**931 McClure Street – Rezoning Application No. 00669
and Development Permit with Variances Application
No. 00127 (Fairfield)**

E.1 931 McClure Street – Rezoning Application No. 00669 and Development Permit with Variances Application No. 00127 (Fairfield)

Committee received a report dated May 20, 2021 from the Director of Sustainable Planning and Community Development regarding the Rezoning Application 00669 and Development Permit with Variances application No. 00127 for the property located at 931 McClure Street in order to construct a five-storey building with approximately 15 dwelling units, and recommending that it move forward to a Public Hearing.

ROOF LEVEL PLAN

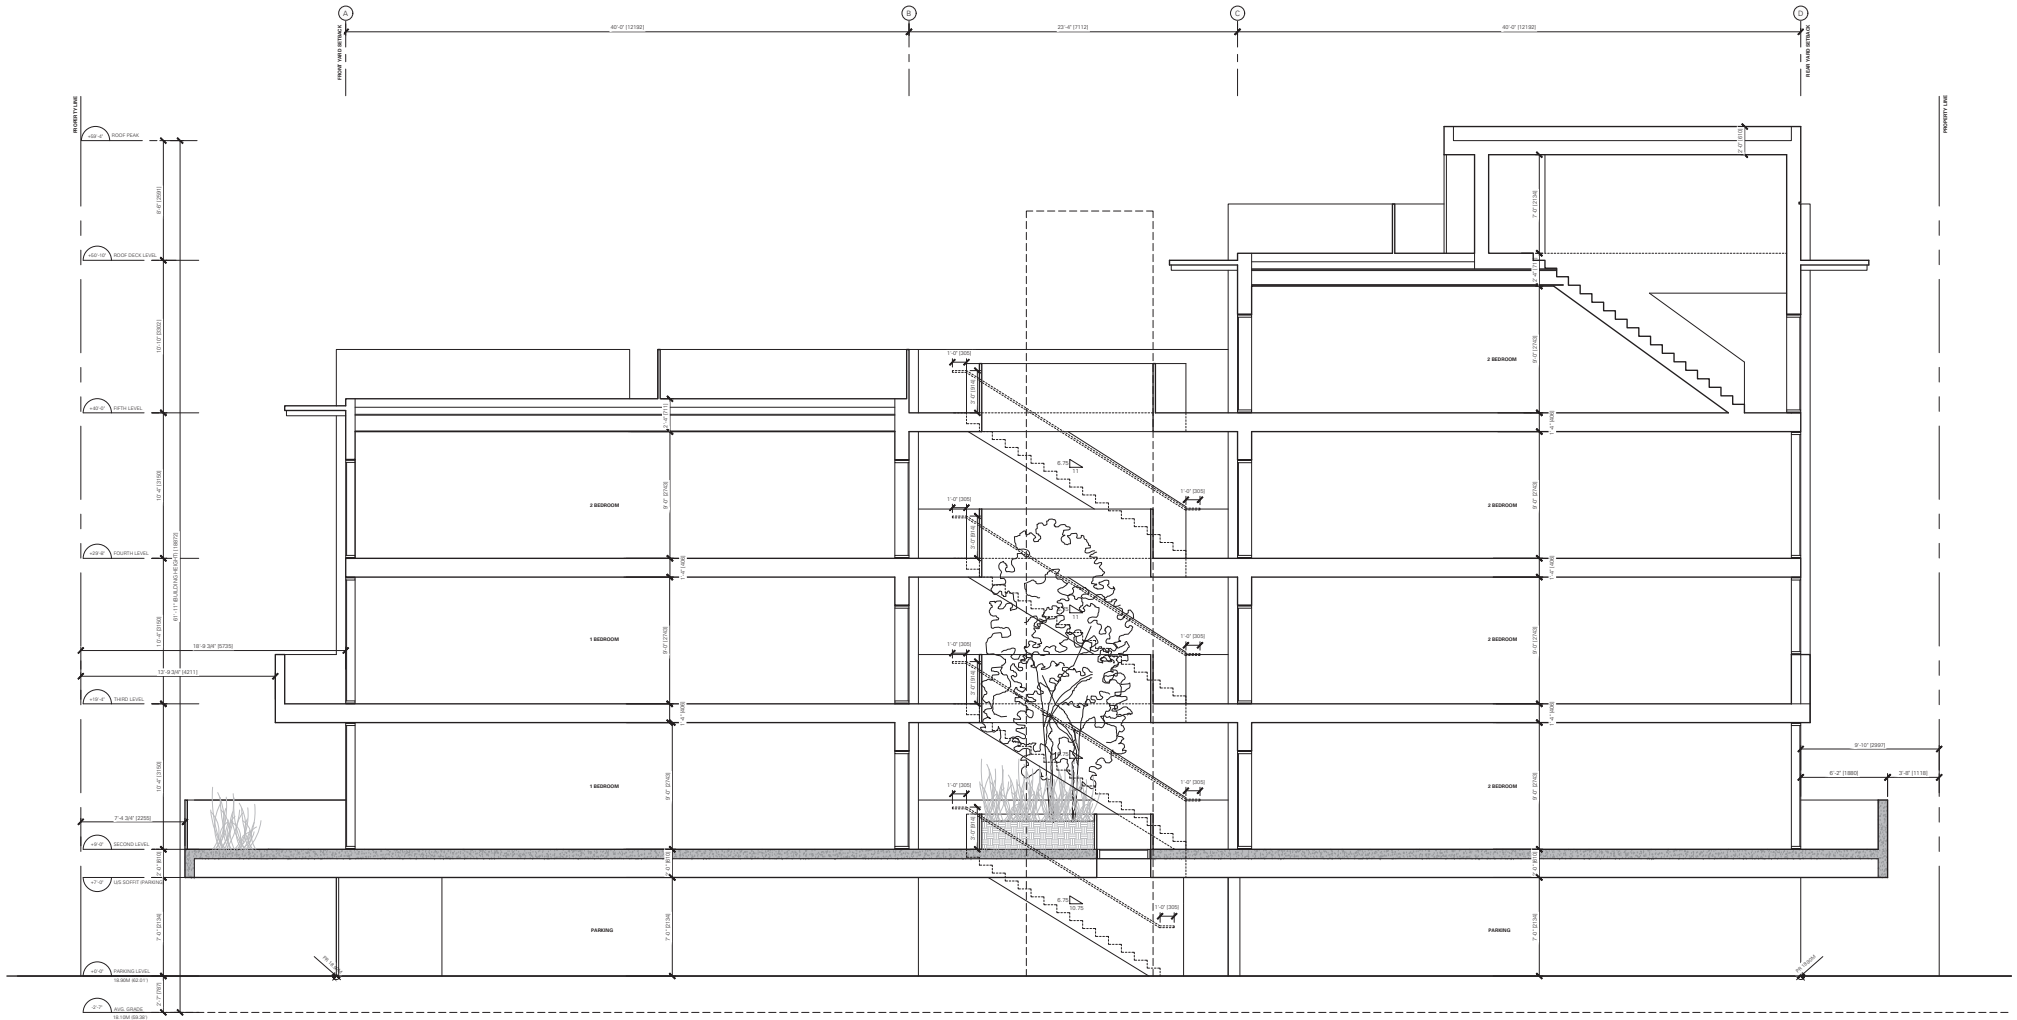
1. Revisions to the proposed rooftop decks to address potential privacy impacts, to the satisfaction of the Director of Sustainable Planning and Community Development.

1. Revisions to the proposed rooftop decks to address potential privacy impacts, to the satisfaction of the Director of Sustainable Planning and Community Development.

East Elevation

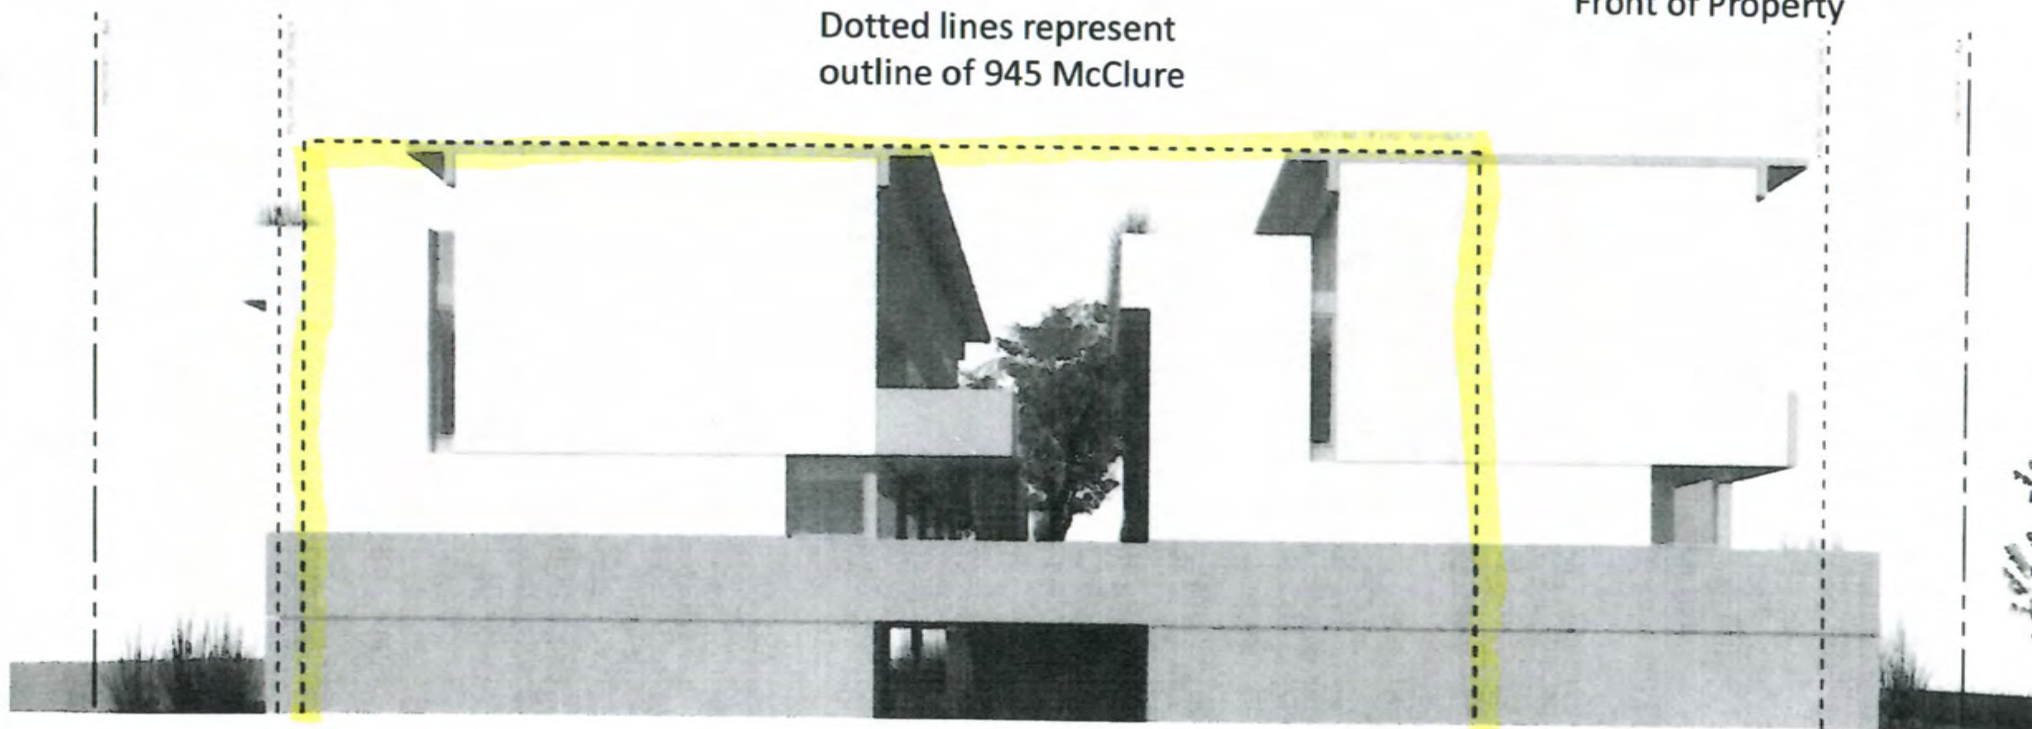
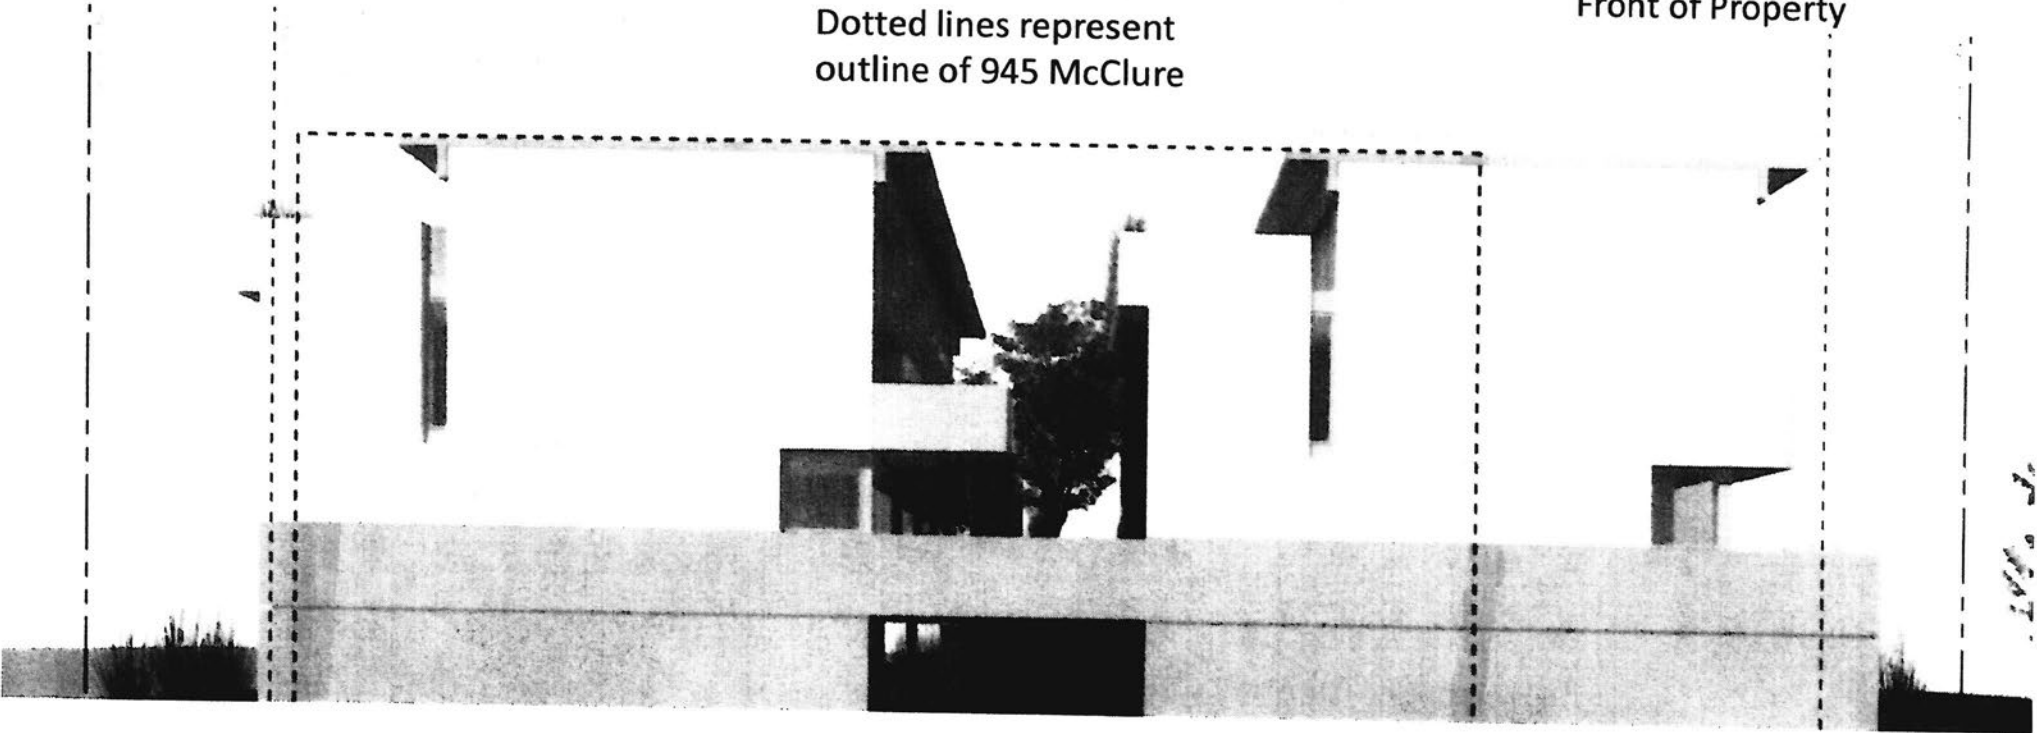
- All neighbours who spoke were not in favour of the current proposal because of its mass.
- “Massiveness of it on a very small lot.”
- Many will be looking at a “blank wall 4 storeys high!” “Basically looking at a wall”
- “I won’t be able to see the sky anymore”
- “Go back the drawing board.”
- “Too much mass! Asking us to look at a blank wall 4 storeys high.”
- “Site coverage is more than double.”
- “3 storeys loom over the sidewalk”

The many windows in our west wall provide owners with multiple views of the neighbourhood that include trees, streetscape, skyscape, and the tower on Christ Church Cathedral. These would all be displaced by a single view of a large blank wall, only feet away.
